Final Drainage Report

Didleau Subdivision Filing 1

Project No. 2019.012

PCD File No: MS206

Forest Heights Drive

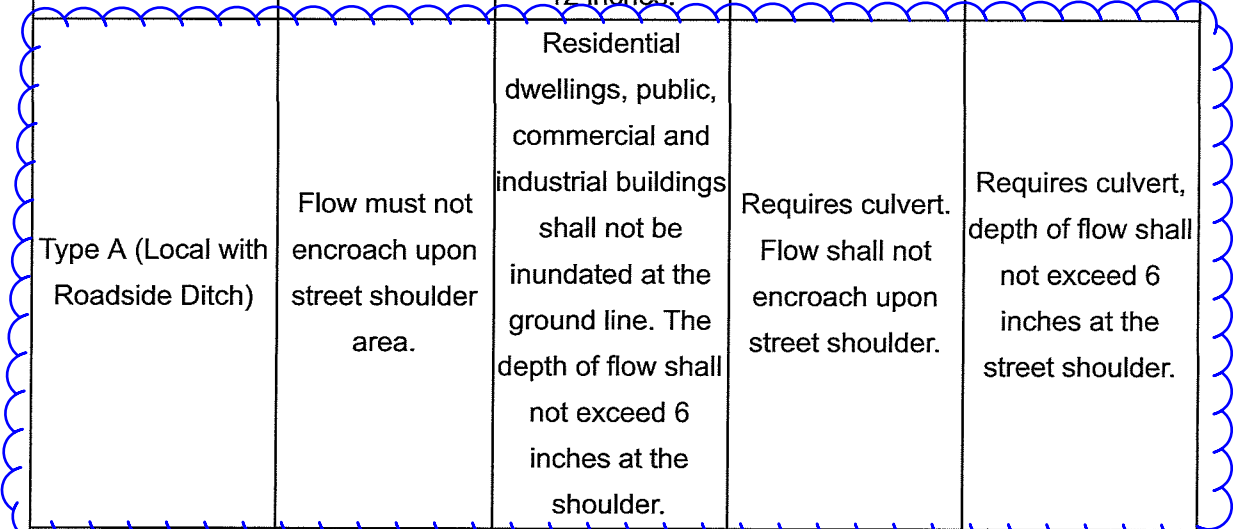
As Forest heights is a rural roadway with roadside ditches the clouded is the criteria that applies. Please analyze the culverts accordingly.

Exhibit 13

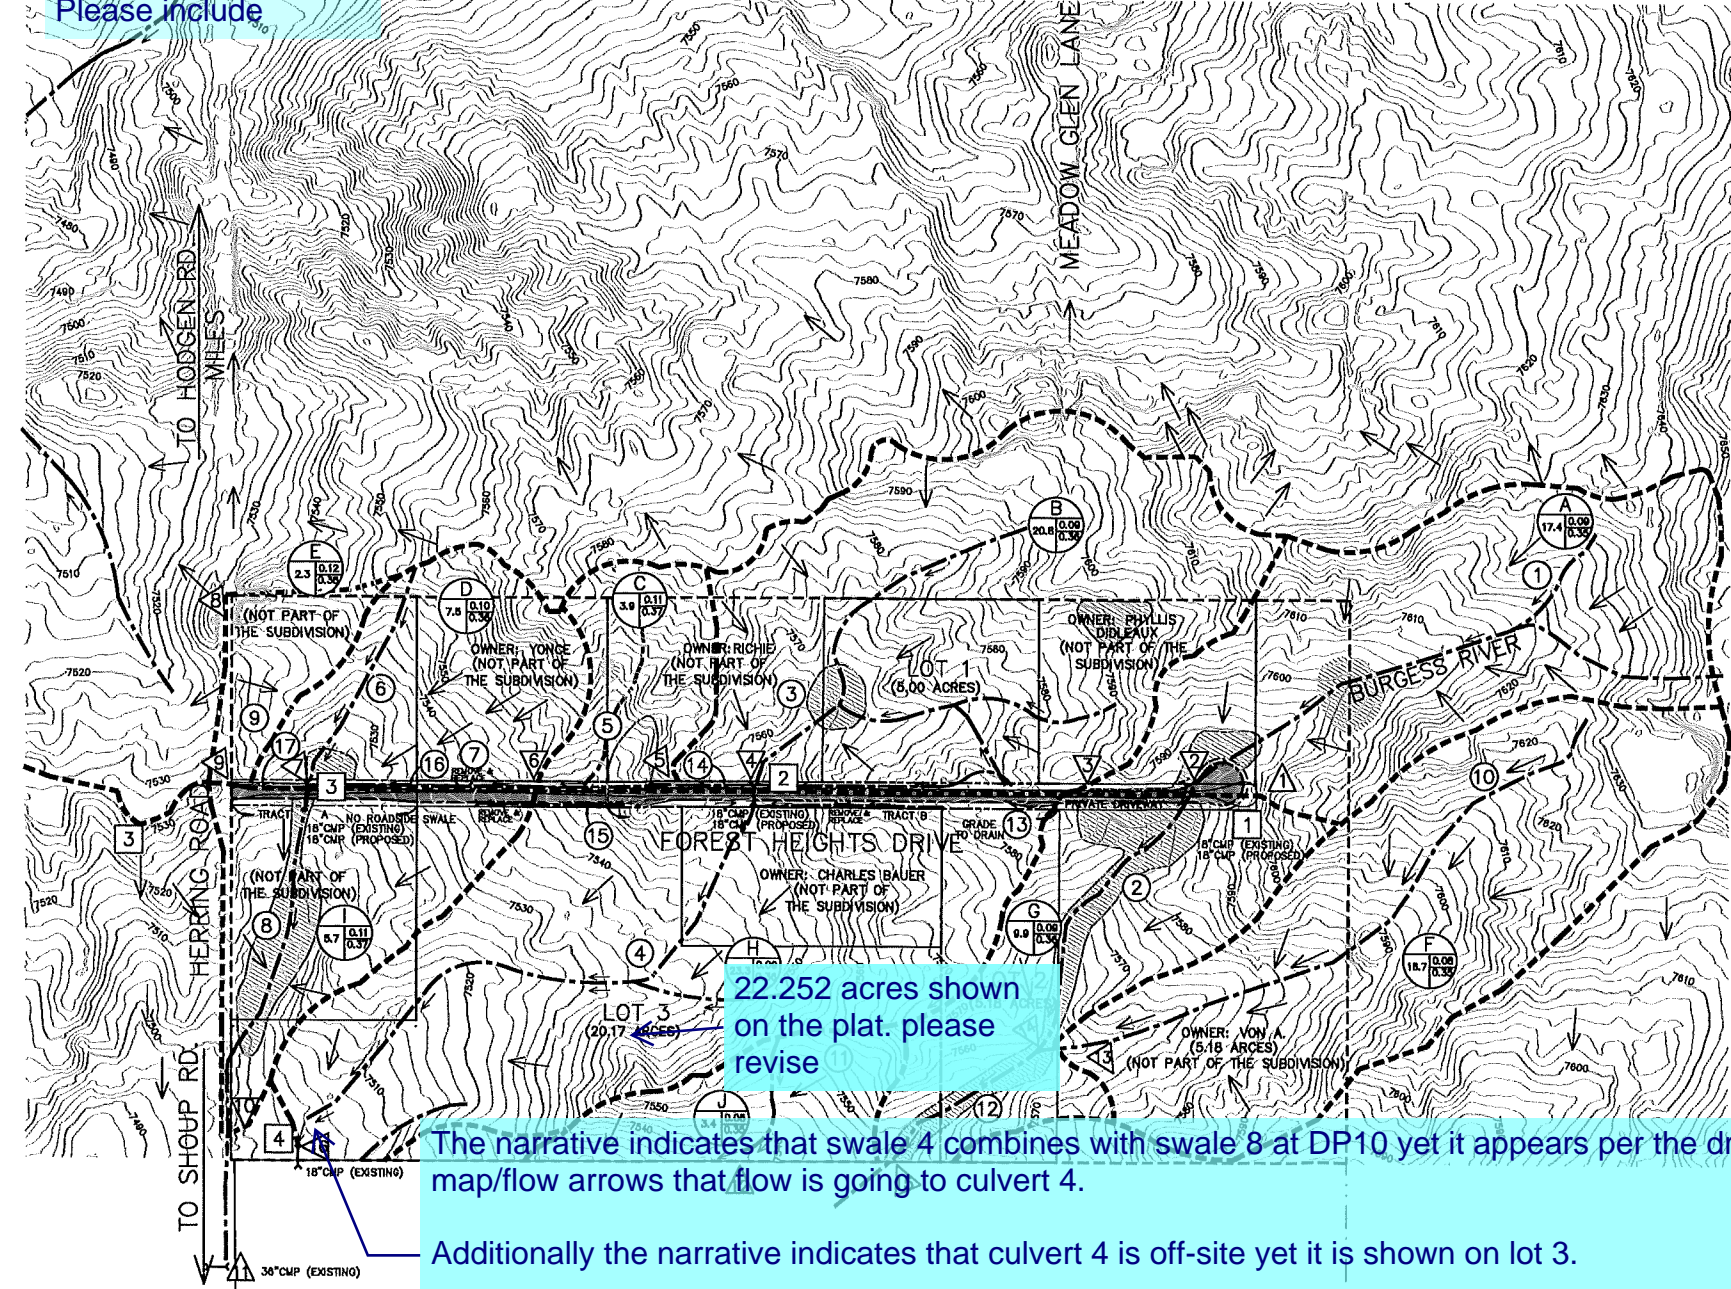
22.252 acres shown on the plat. please revise
